# SERVICE BULLETIN

| Classification:<br>EL14-031d | Reference:<br>NTB14-059d | Date:<br>January 7, 2020 |

## 2011-2016 LEAF; 24 KWH HIGH VOLTAGE REPLACEMENT BATTERY PACK

Figure 1

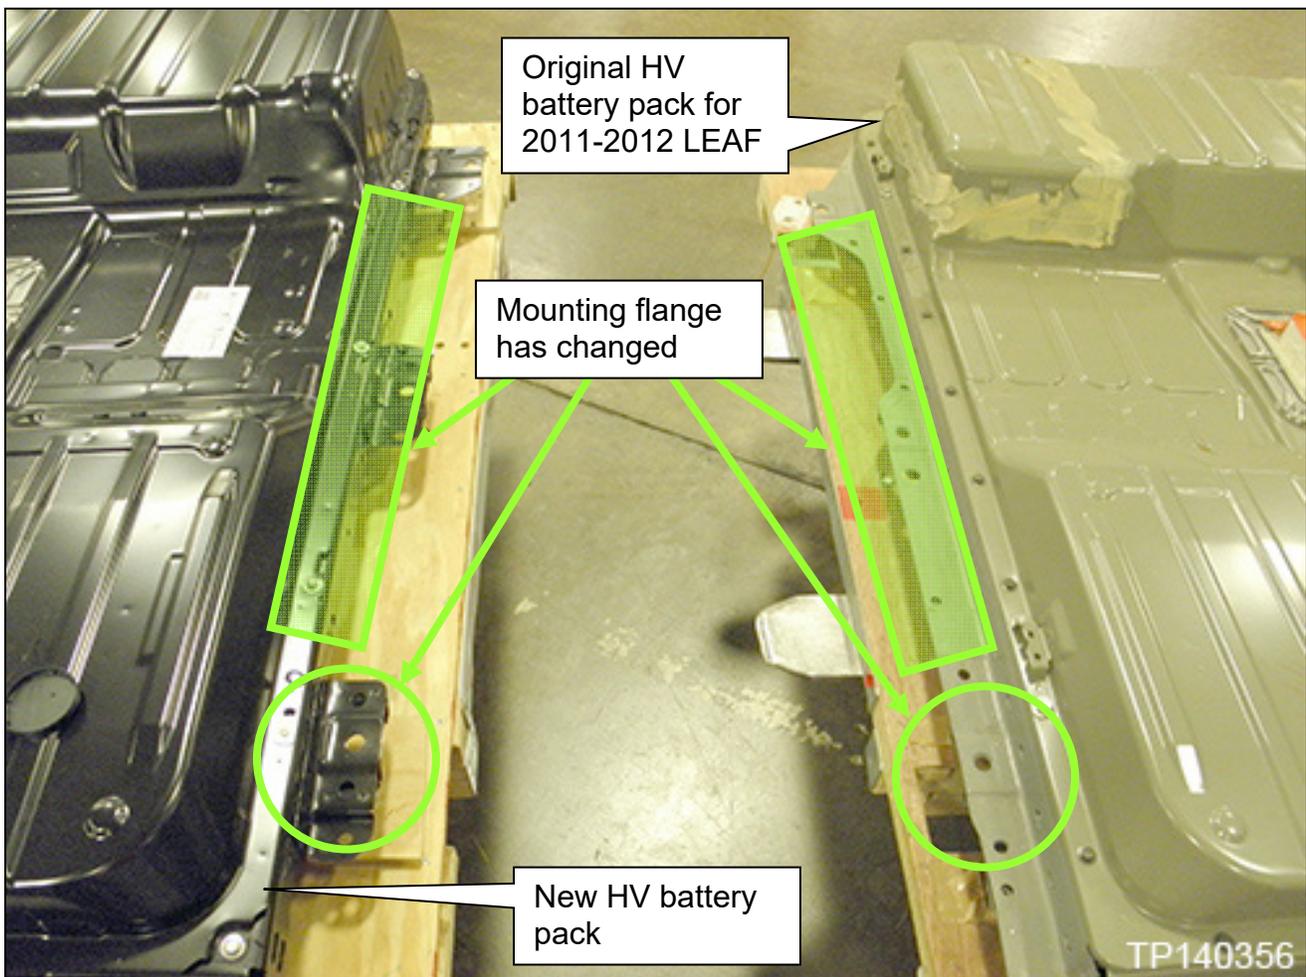
Figure 1 shows the new and old HV Battery Packs side by side.

**NOTE:** For 2013-2016 vehicles, the new HV Battery Pack is a direct replacement and does not require this retrofitting procedure.

Figure 2

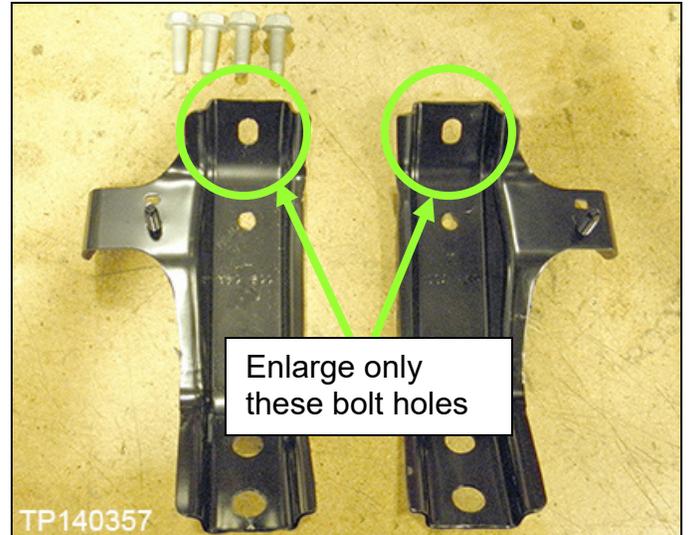
- b. With a 1/2" drill bit, enlarge the bolt holes indicated in Figure 2
    - c. Cover the newly exposed metal with a zinc rich paint to prevent corrosion.
      - After the paint has dried and before assembling the brackets to the new HV battery, Bitumen wax will also be applied to these areas.

Figure A

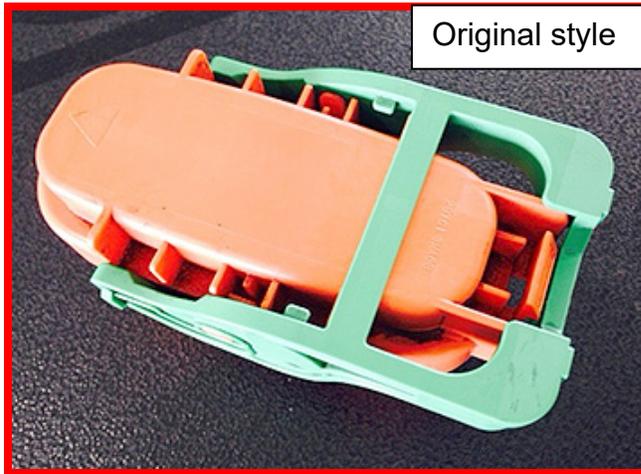
**IMPORTANT:** The original style SDSW (Figure A) cannot be used with any of the battery pack assemblies listed on the previous page. Figure B shows the New style SDSW that is to be used. The two styles are not interchangeable.
